Project	IEEE 802.16 Broadband Wireless Access Working Group < http://ieee802.org/16 >	
Title	Changes to Ranging parameter adjustment Diagram Figure 60	
Date Submitted	2004-04-14	
Source(s)	David A Castelow, Gavin Meakes Airspan Communications, Cambridge House, Oxford Road, Uxbridge, UK	Voice: +44 1895 467281 Fax: +44 1895 467202 mailto:dcastelow@airspan.com
Re:	Supporting document for Sponsor Ballot Recirculation	
Abstract	Additional changes to the standard are required as a result of the Resolution of Comment	
Purpose	The document is intended for consideration within comments resolution process.	
Notice	This document has been prepared to assist IEEE 802.16. It is offered as a basis for discussion and is not binding on the contributing individual(s) or organization(s). The material in this document is subject to change in form and content after further study. The contributor(s) reserve(s) the right to add, amend or withdraw material contained herein.

Changes to Ranging parameter adjustment Diagram Figure 60

Figure 60 Initial Ranging—BS

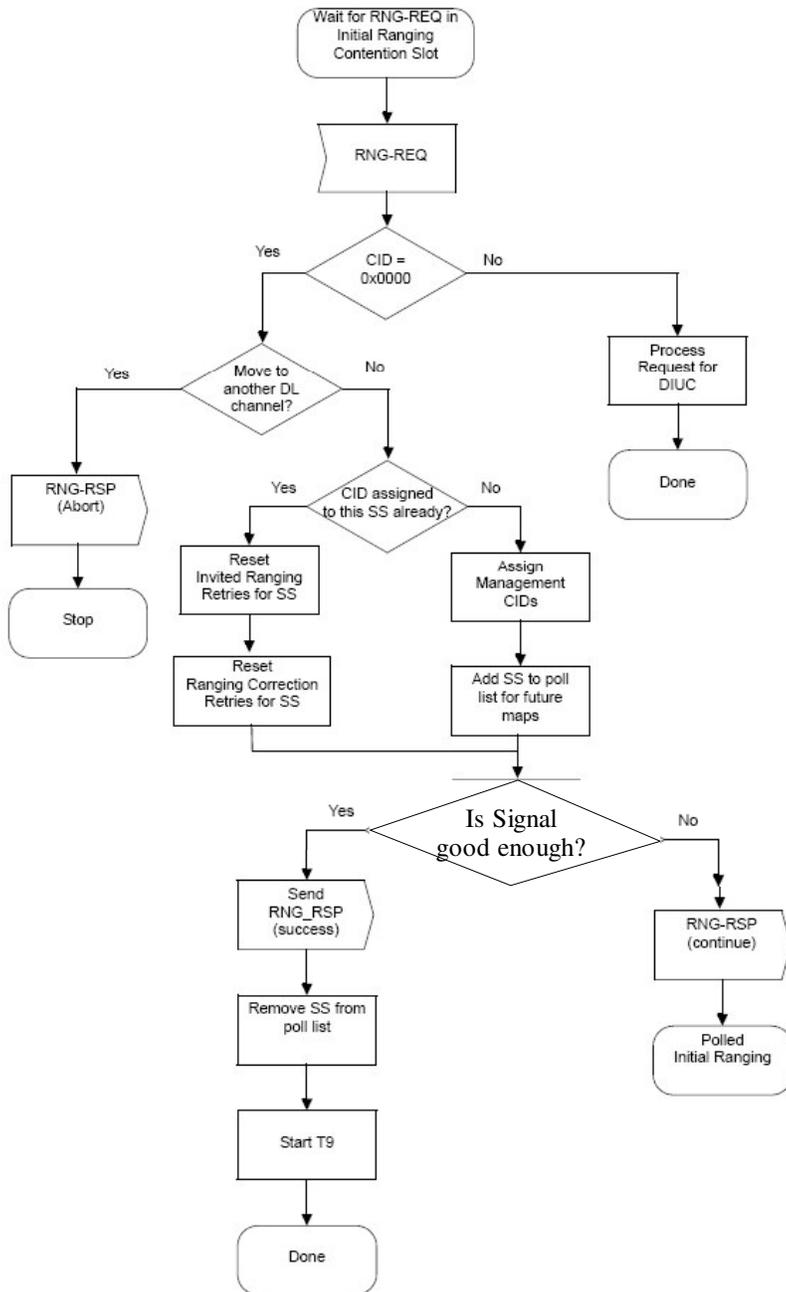
In section 6.3.9.6 of [1], Ranging parameter adjustment, Figure 60 does not allow for an immediate continuation to "RNG-RSP (success)" in the event that all parameters are within the tolerance, but instead requires further unnecessary messages to be exchanged.

This can be resolved by replacing figure 60, page 162, by the diagram on the next page. The decision diamond and left hand branch have been taken from Figure 61, page 163.
